April 12, 2011

Subject: Review of Closure Plan for SLIC Case RO0002952 and Geotracker Global ID SL0600101555, Hanson Aggregates Radum Plant, 3000 Busch Road, Pleasanton, CA 94566

HAZARDOUS MATERIALS  
STORAGE AREAS  
 PAGE 4 of 13

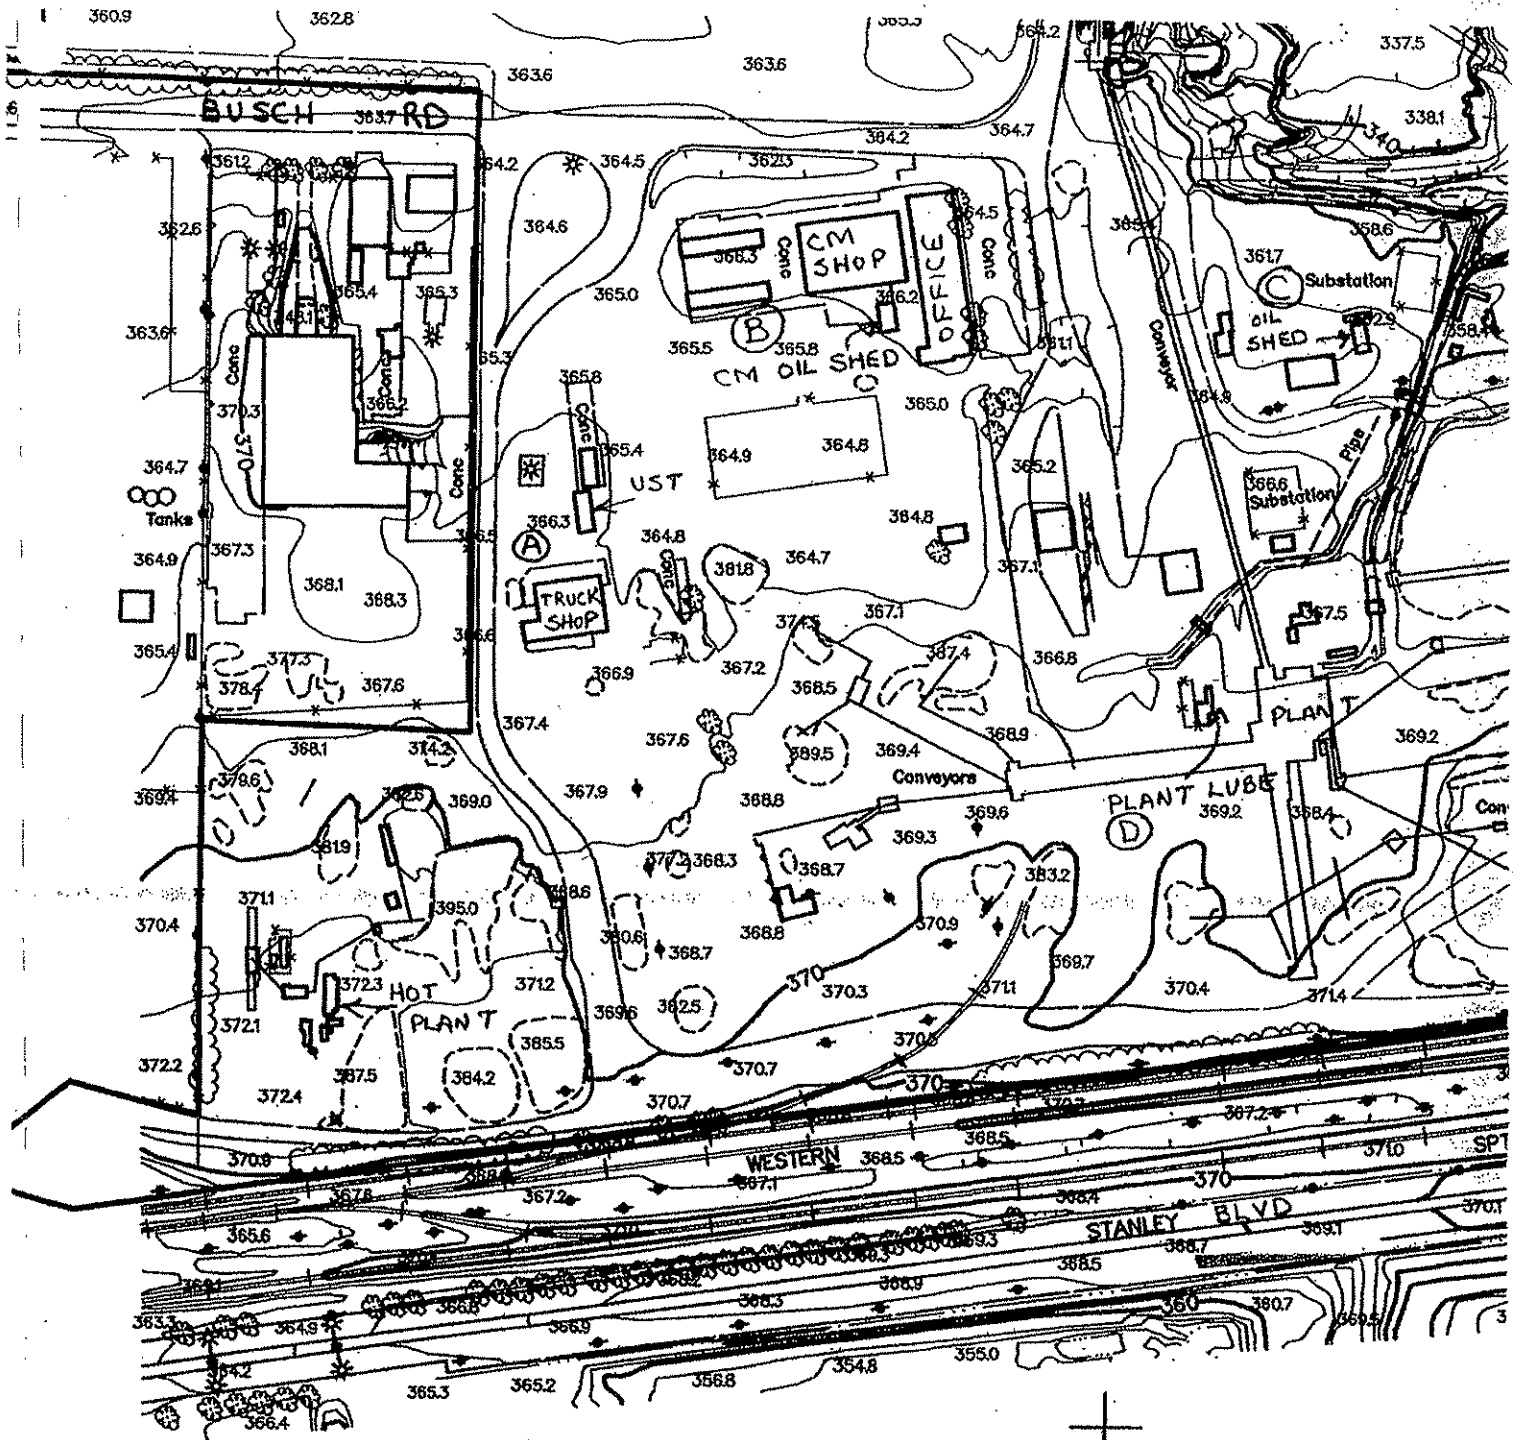
15. **Substations.** Two power substations were formerly present in the central portion of the site as shown on a figure labeled, "*Hazardous Materials Storage Areas*," which is located in Appendix B of the January 28, 2005 Baseline Environmental Consulting Closure Plan Report. Recognized or potential environmental concerns at these two substations do not appear to be addressed in any of the existing Work Plans or Reports for this site. In the Revised Closure Plan requested below, please propose investigation activities to assess whether any releases occurred in the areas of the two substations.

- 21. Former Plant Lube.** A building labeled, "Plant Lube D," is shown in AOC 5 on a figure labeled, "*Hazardous Materials Storage Areas*," which is located in Appendix B of the January 28, 2005 Baseline Environmental Consulting Closure Plan Report (Attachment 1 to this correspondence). A "California Hazardous Materials Reporting Form," indicates that various oils, greases, and cleaning solvents were stored at the Former Plant Lube. In the Revised Closure Plan, please provide background information and propose investigation of this area.
